Staff Report

Knoxville Historic Zoning Commission

File Number: 4-A-26-HZ

Location: 2038 Jefferson Ave. **Parcel ID** 82 O A 010
District: Edgewood-Park City H
Zoning: RN-2 (Single-Family Residential Neighborhood)
Description: Queen Anne, c.1880

DECK

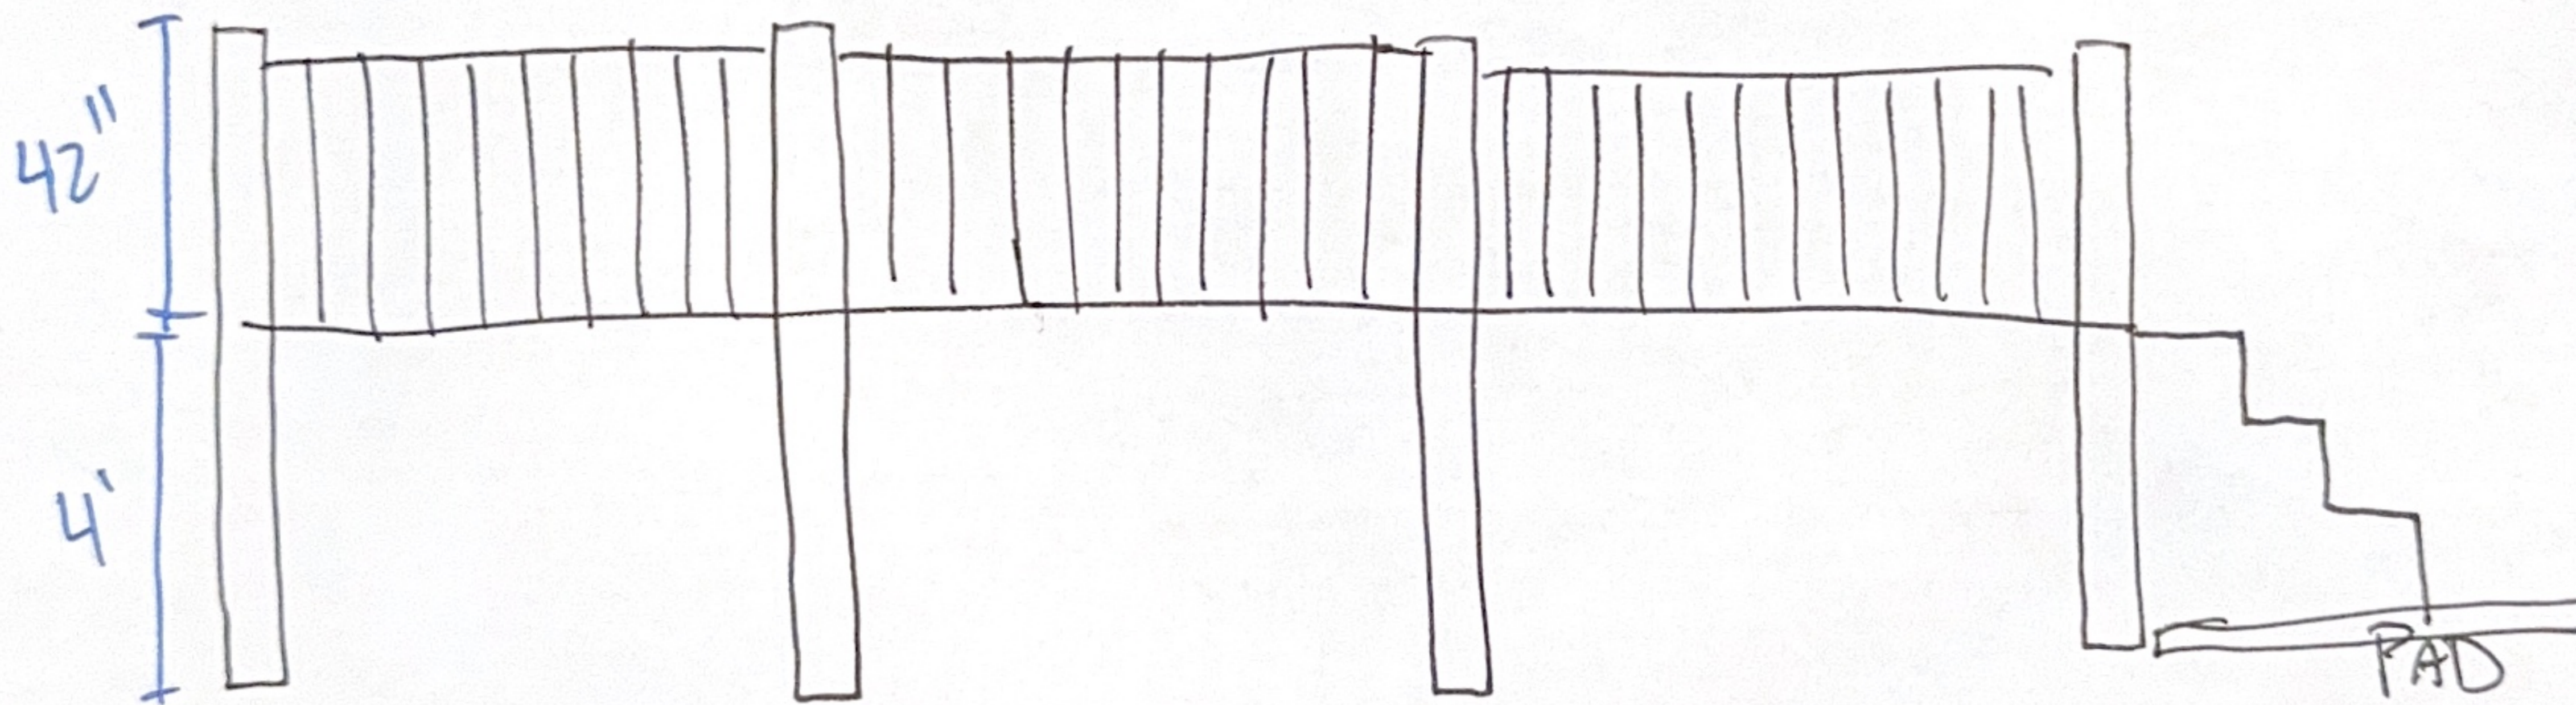
5. The rear deck is compatible in size with the primary structure and could be removed without adverse effects. Its railing does not feature balusters set into the top and bottom rails, and the contemporary deck design is not specifically compatible with the overall design, material, and detail of the primary structure and its ornate porches. Similar decks have been approved in the overlay prior to the adoption of the current guidelines in 2025. Although the contemporary deck is screened by fencing, the top of the deck is visible from Polk Street. Trim pieces could be added to give the appearance that the balusters are set in the top and bottom rails, but this would have a minimal effect on the streetscape and on the deck's compatibility with the primary structure.
-

SHED

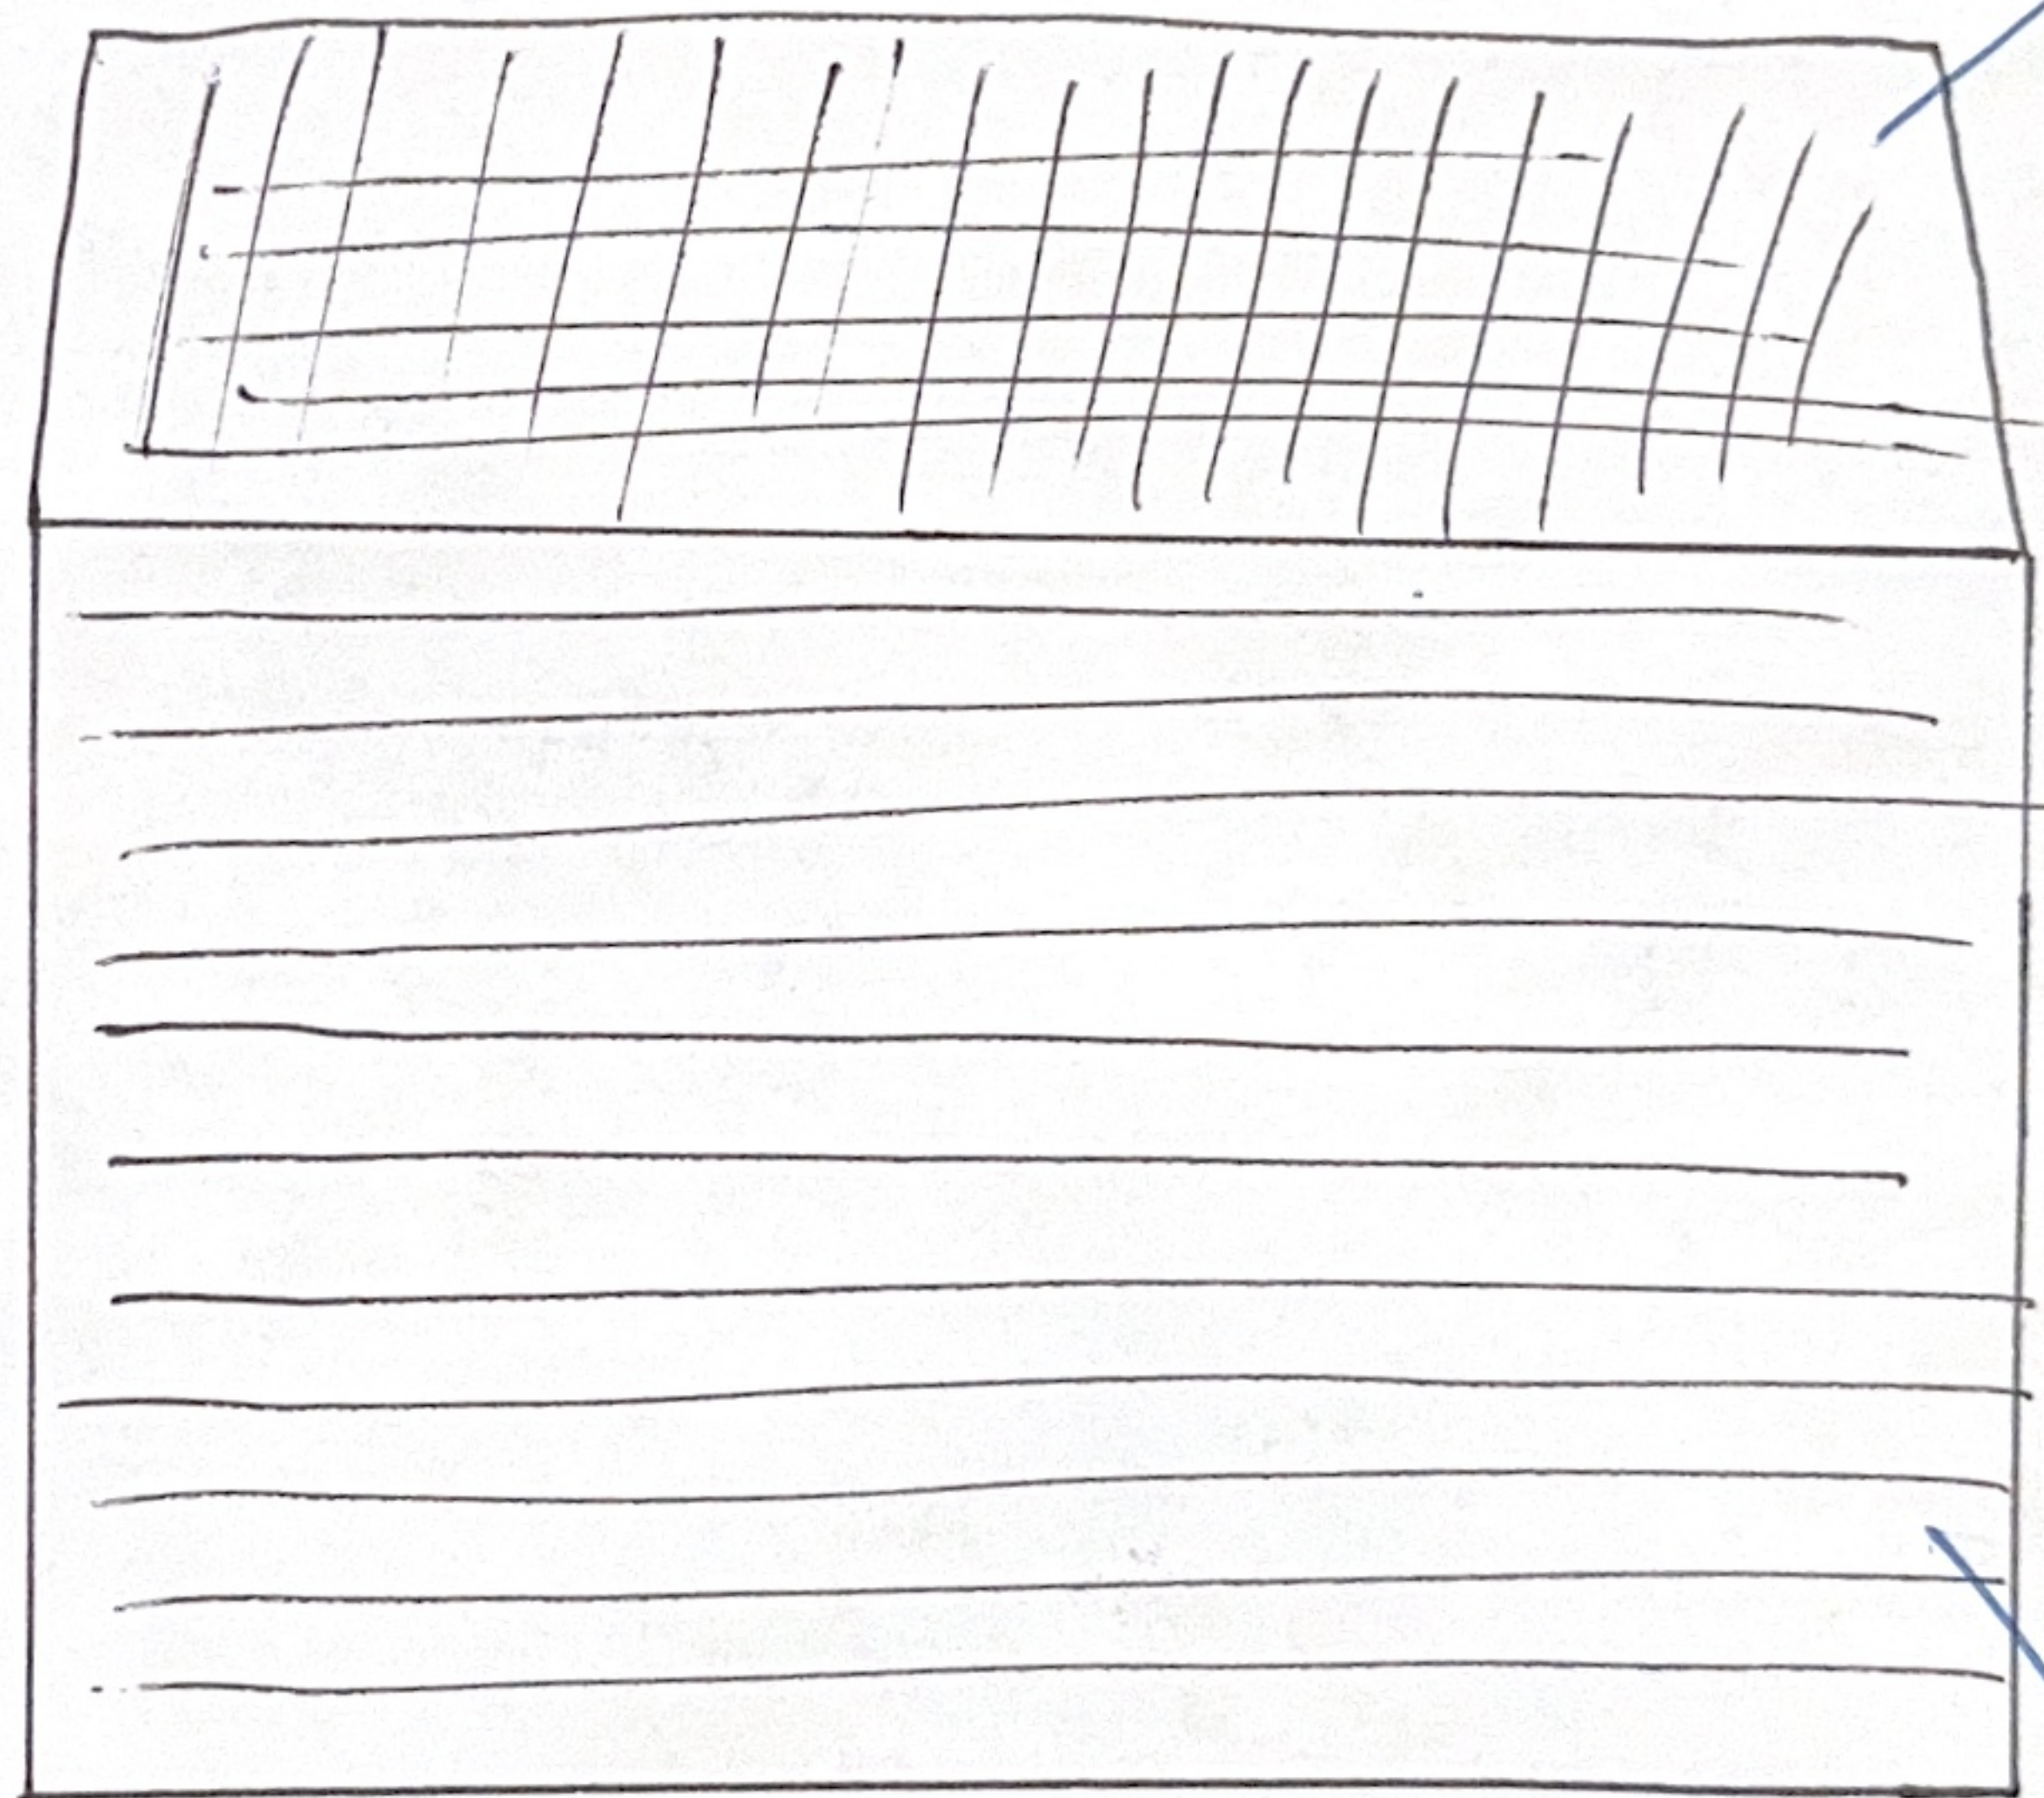
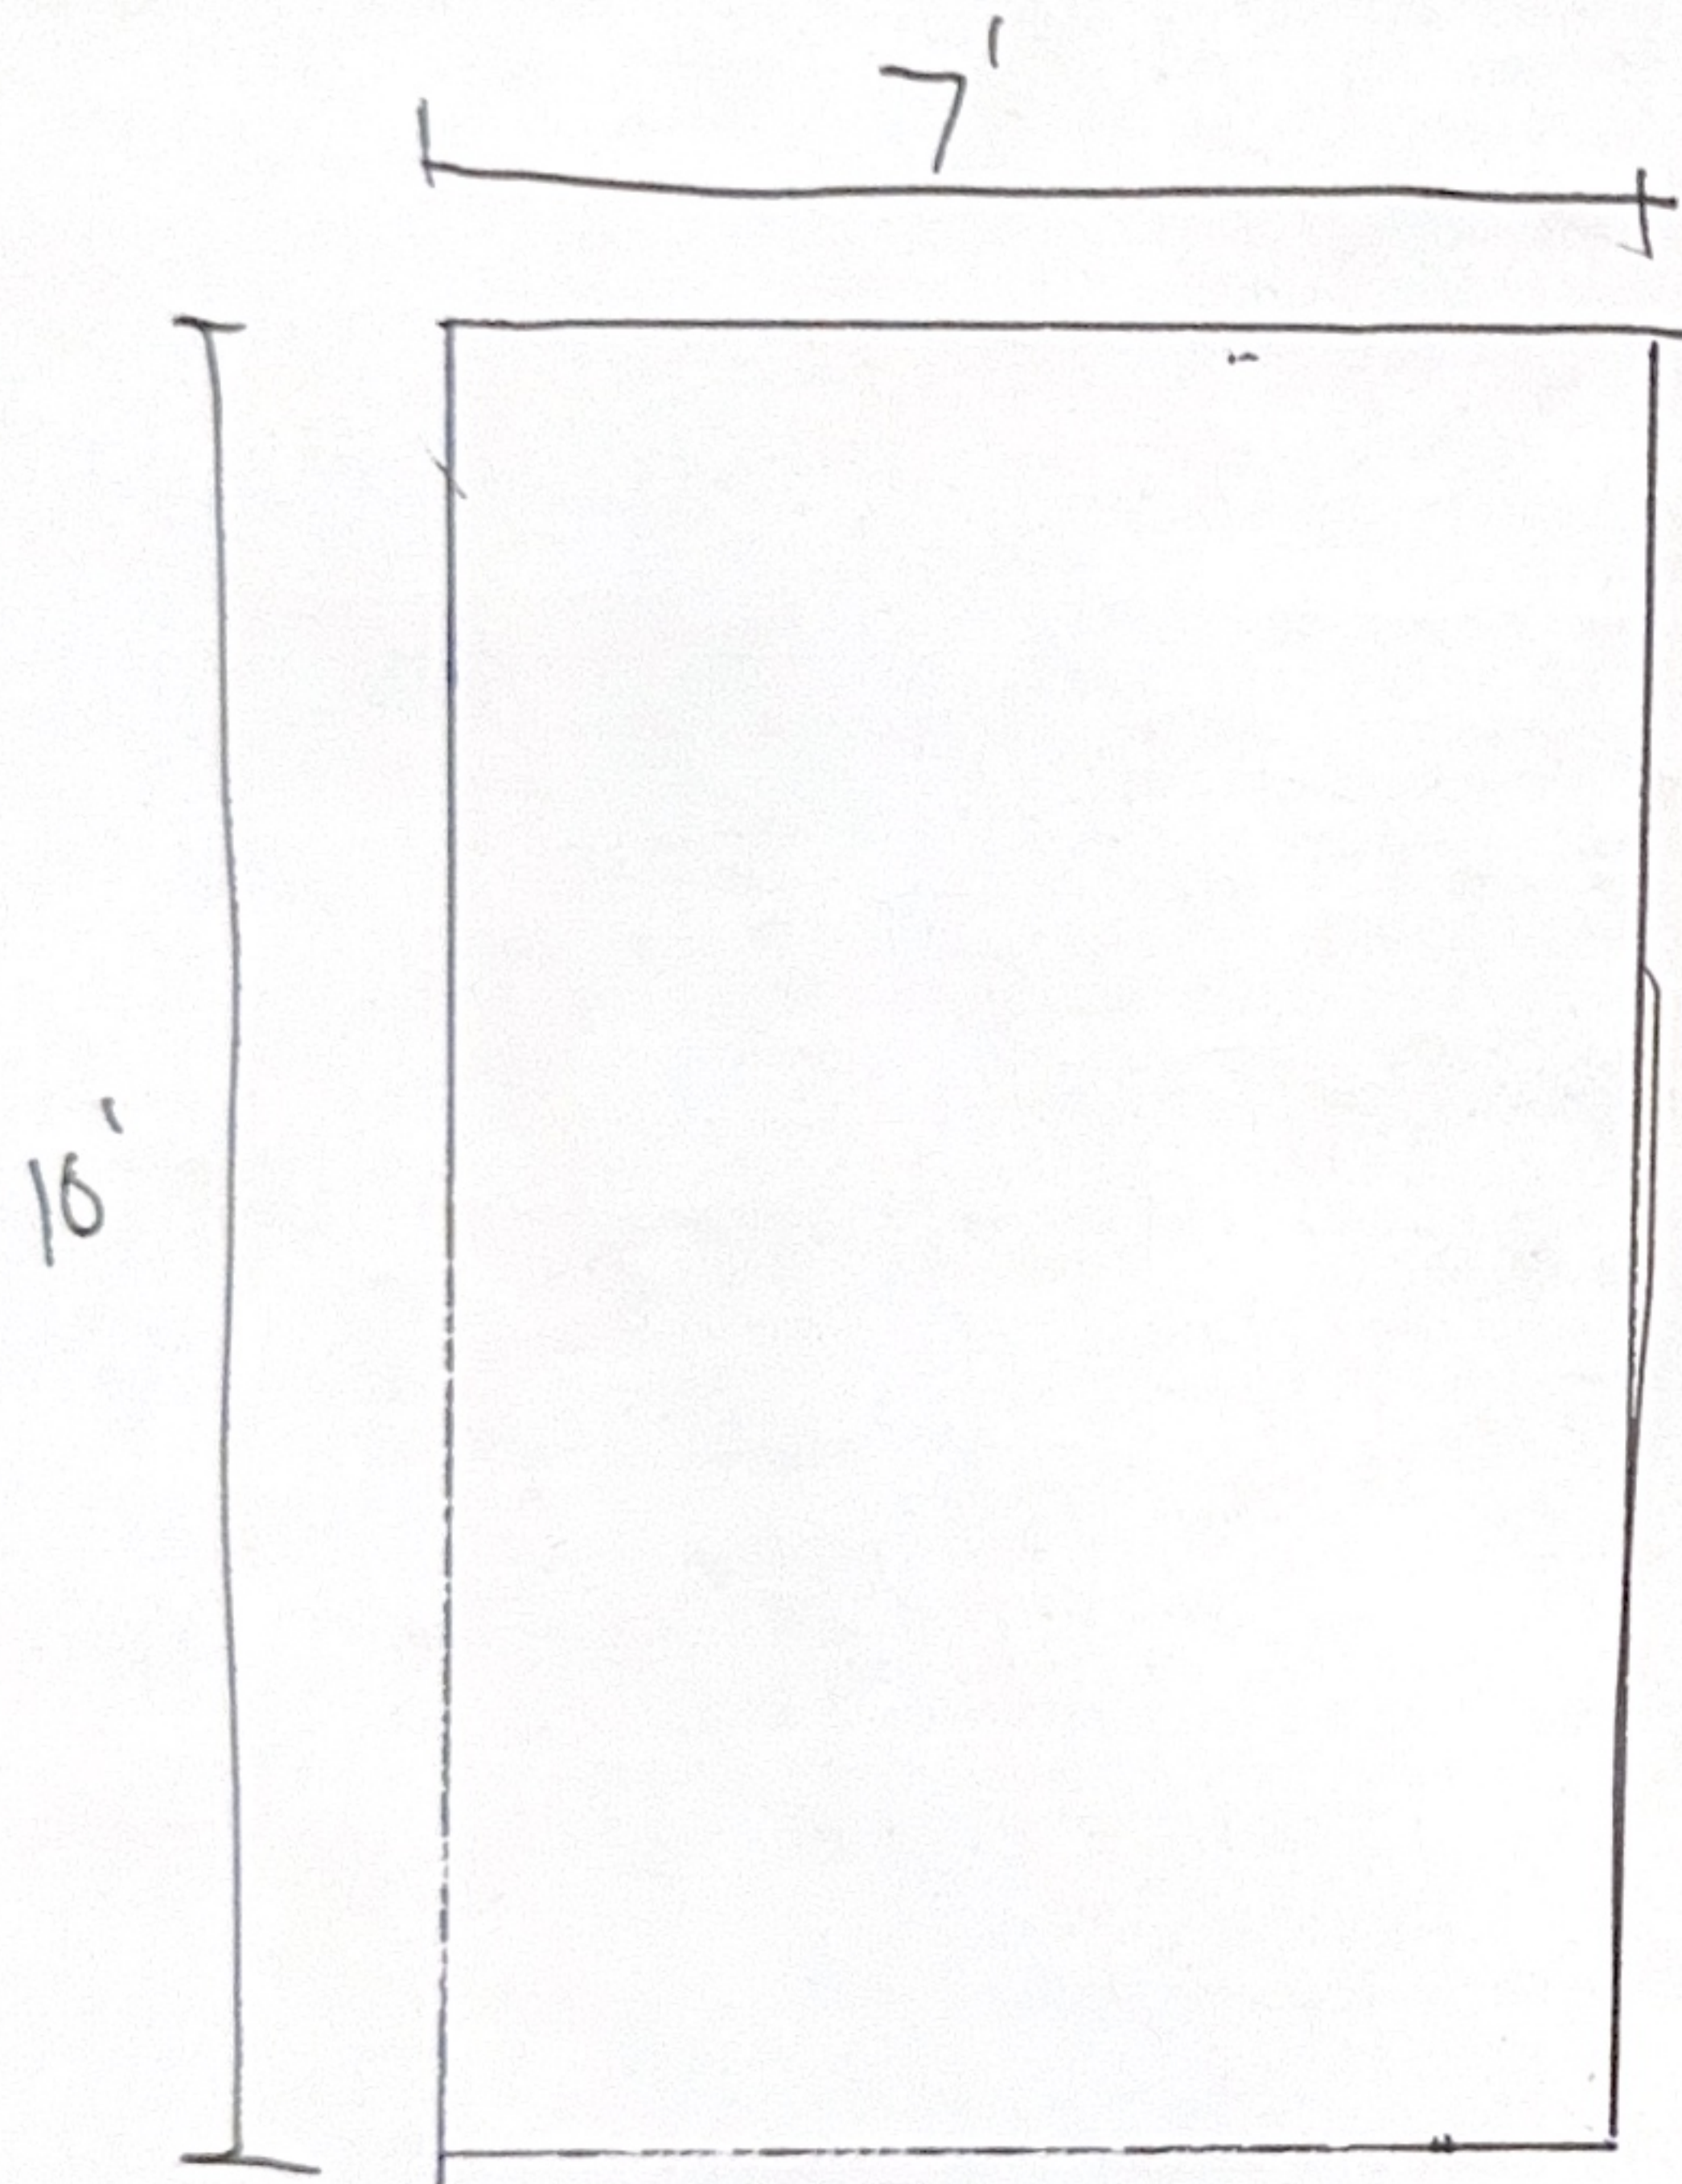
4. The size of the shed is appropriate, but it does not currently meet guideline recommendations for placement or materials. The proposed addition of fiber cement lap siding in-kind to the house addresses the inappropriate existing T-111 siding. Relocating the shed would make it more visible from Polk Street, as it is currently minimally visible from the street due to the fencing and trees in the front yard.

Staff recommends approval of Certificate 4-A-26-HZ, subject to the following condition: 1) cladding the shed in fiber cement lap siding with in-kind exposure to the house, to be approved by staff.
